Access Compliance Report

Public Rights-of-Way

(Curb Ramps)

Intersection ID: 10022636	Main Street: CARMEL_RD	Cross Street: N/A	Location: SE
ADA ID: 6740D58D50D7	Ramp Type: PerpDiag	Initial Pass/Fail: Fail	Overall Compliance: No
Severity Score: 21.25			
Codes/Mitigation Info/Possible Solution		Field Measurements/Component Compliance

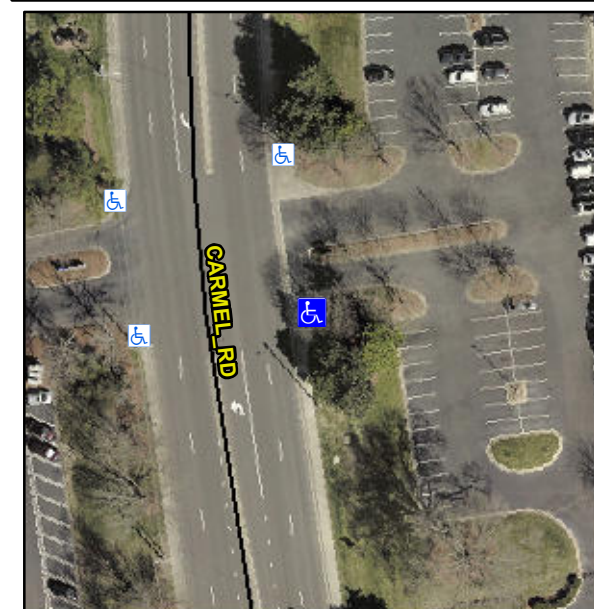
Not Found, R304.5.1, R304.2.2

Compliance	Description	Data	Compliance	Description	Data
N/A	Ramp Length (in)	59.5	No	Ramp Slope (%)	8.5
No	Ramp Width (in)	46.0	Yes	Ramp XSlope (%)	1.8
N/A	Flare Type LT	N/A	N/A	Flare Type RT	N/A
N/A	Flare Slope LT (%)	N/A	N/A	Flare Slope RT (%)	N/A
N/A	Flare Traversable LT?	N/A	N/A	Flare Traversable RT?	N/A
N/A	Landing Length (in)	N/A	N/A	DWS Provided?	N/A
N/A	Landing Width (in)	N/A	N/A	DWS Contrast?	N/A
N/A	Landing Slope (%)	N/A	N/A	DWS Length (in)	N/A
N/A	Landing X Slope (%)	N/A	N/A	DWS Full Width?	N/A
N/A	Landing Curb? (Y/N)	N/A	N/A	DWS Offset (in)	N/A
N/A	Shared Landing?	N/A			
N/A	Gutter Ponding?	N/A	N/A	Gutter Slope (%)	N/A
N/A	Gutter Lip Ht (in)	N/A	N/A	Gutter X Slope (%)	N/A
N/A	Painted X Walk1?	No	N/A	Painted X Walk2?	No
	X Walk 1 Direction	To N		X Walk 2 Direction	To W
N/A	X Walk 1 Width (in)	N/A	N/A	X Walk 2 Width (in)	N/A
	X Walk 1 Slope (%)	1.0		X Walk 2 Slope (%)	0.9
	X Walk 1 X Slope (%)	5.2		X Walk 2 X Slope (%)	1.1

Remove & Replace Curb Ramp With Two New Directional Ramps or Equivalent.
